# UNITED STATES PATENT AND TRADEMARK OFFICE

APPLICATION NO.	FILING DATE	FIRST NAMED INVENTOR	ATTORNEY DOCKET NO.	CONFIRMATION NO.
10/618,650	07/15/2003	Hiroshi Kondoh	240266US2	5255
22850	7590	05/12/2005	EXAMINER	
OBLON, SPIVAK, MCCLELLAND, MAIER & NEUSTADT, P.C.			TRAN, LONG K	
1940 DUKE STREET			ART UNIT	
ALEXANDRIA, VA 22314			PAPER NUMBER	
			2818

**Office Action Summary**

## **DETAILED ACTION**

**FIG. 2****FIG. 3**

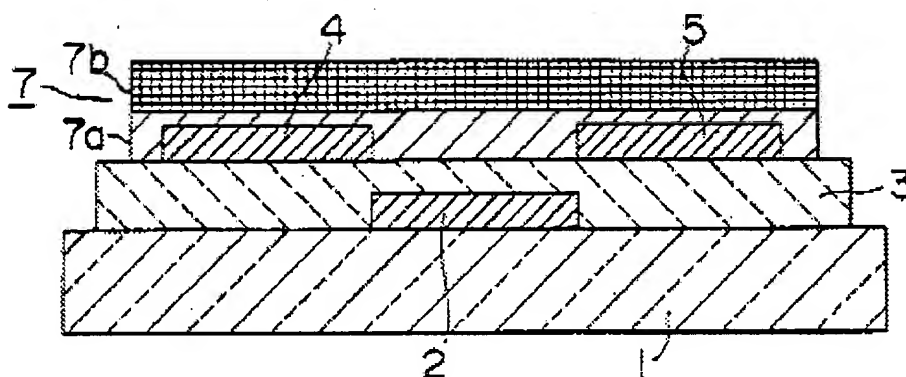
7. Regarding claim **1**, Tsumura discloses a semiconductor device, comprising: a gate electrode 2 (fig. 2);

an insulating layer 3 (fig. 2) on the gate electrode; a first electrode 4 (fig. 2) on the insulating layer; a second electrode 5 (fig. 2) on the insulating layer at an interval with the first electrode;

an organic semiconductor layer 7a (fig. 2; col. 6, lines 7 – 9) disposed in the interval between the first electrode and the second electrode and covering at least part of the first electrode and the second electrode; and

a first resistance layer 7b (fig. 2; col. 6, lines 7 – 9) formed on the organic semiconductor layer and having an electrical resistance lower than an electrical resistance of the organic semiconductor layer (col. 6, lines 18 – 21).

Regarding claim **6**, Tsumura discloses the resistance layer is formed to be a plate shape (figs. 2 & 3).

8. Regarding claim **29**, Tsumura discloses a liquid crystal display device (col. 1, lines 23 – 24), comprising: a gate electrode 2 (fig. 2);

an insulating layer 3 (fig. 2) on the gate electrode; a first electrode 4 (fig. 2) on the insulating layer; a second electrode 5 (fig. 2) on the insulating layer at an interval with the first electrode;

an organic semiconductor layer 7a (fig. 2; col. 6, lines 7 – 9) disposed in the interval between the first electrode and the second electrode and covering at least part of the first electrode and the second electrode; and

a first resistance layer 7b (fig. 2; col. 6, lines 7 – 9) formed on the organic semiconductor layer and having an electrical resistance lower than an electrical resistance of the organic semiconductor layer (col. 6, lines 18 – 21).

Regarding claim **2**, figure 2 illustrates both a distance from the first electrode to the first resistance layer and a distance from the second electrode to the first resistance layer appear to be shorter than the interval between the first electrode and the second electrode. Kim does not explicitly shows the values of the distances between the electrodes to the first resistance layer and the interval between the electrodes.

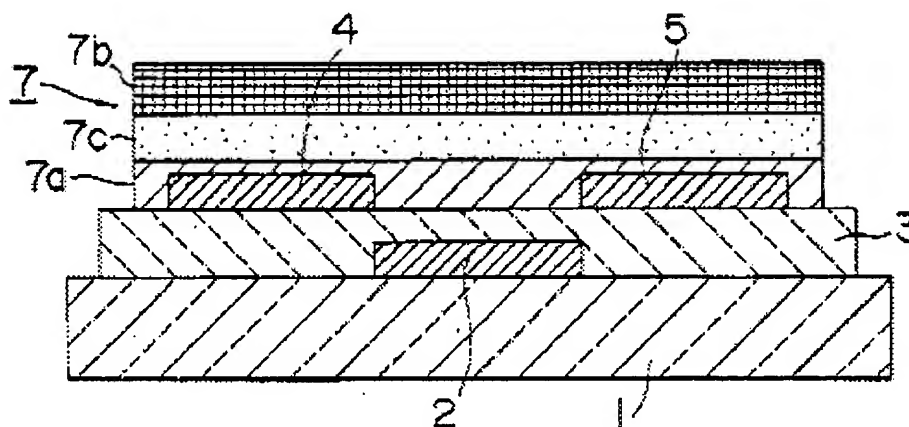
Regarding claim **4**, Kim discloses a second resistance layer 7c (fig. 3) formed at least at one of the position between the first resistance layer 7b (fig. 3) and the organic semiconductor layer 7a (fig. 3), wherein the second resistance layer has an electrical resistance so that carriers in the organic semiconductor layer are allowed to tunnel through the second resistance layer when a voltage of a predetermined value or more than the predetermined value is applied across the second resistance layer (col. 7, lines 24 – 35).

However, Ong shows a gate dielectric layer (same as the organic layer 7a (figs. 2 and 3 of Tsumura)) "is comprised of silicon nitride, silicon oxide, insulating polymers of a polyester, a polycarbonate, a polyacrylate, a poly(methacrylate), a poly(vinyl phenol), a polystyrene, a polyimide, an epoxy resin, an inorganic-organic composite material of nanosized metal oxide particles dispersed in a polymer, a polyimide, or an epoxy resin" ([0015], page 3, mid-left column).
